# Access Compliance Report Public Rights-of-Way (Curb Ramps)

| Main Street: COW_CAMP_RD |                                   | Cross Street: CHIQUITA_CANYON_DR |                        | Location:       | S  |
| ADA ID: RPRK211124121020 | Ramp Type: Type 1 - Perpendicular | Initial Pass/Fail: Pass          | Overall Compliance: No | Severity Score: | 10 |

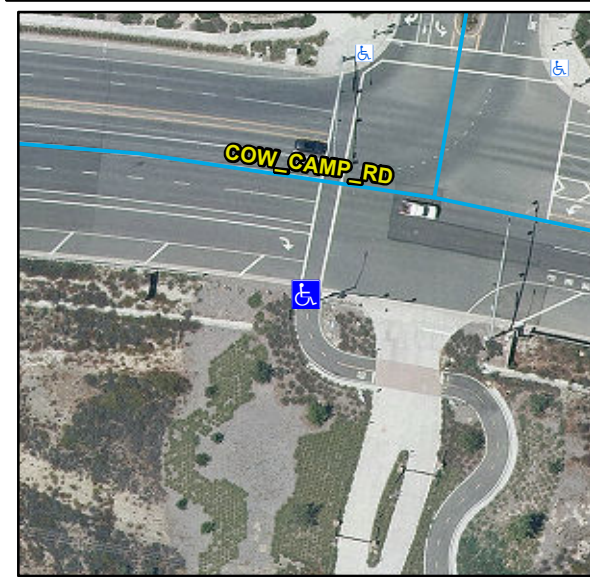
R304.2.1, R304.2.2-Perp, R304.3.2-Para, R304.5.3, R302.7, STD 1115

| Compliance | Description                           | Data | Compliance | Description                   | Data    |
|------------|---------------------------------------|------|------------|-------------------------------|---------|
| No         | Landing Width (in)                    | N/A  | N/A        | Flare Slope RT (%)            | N/A     |
| No         | Landing Run Slope (%)                 | N/A  | N/A        | Flare Traversable RT          | N/A     |
| No         | Landing Cross Slope (%)               | N/A  | Yes        | DWS Provided                  | Yes     |
| No         | Gutter Ponding                        | Yes  | Yes        | Curb Slope                    | 0.3     |
| No         | Gutter Cross Slope (%)                | 2.2  |            |                               |         |

Install Landing. Remove & Replace Gutter.
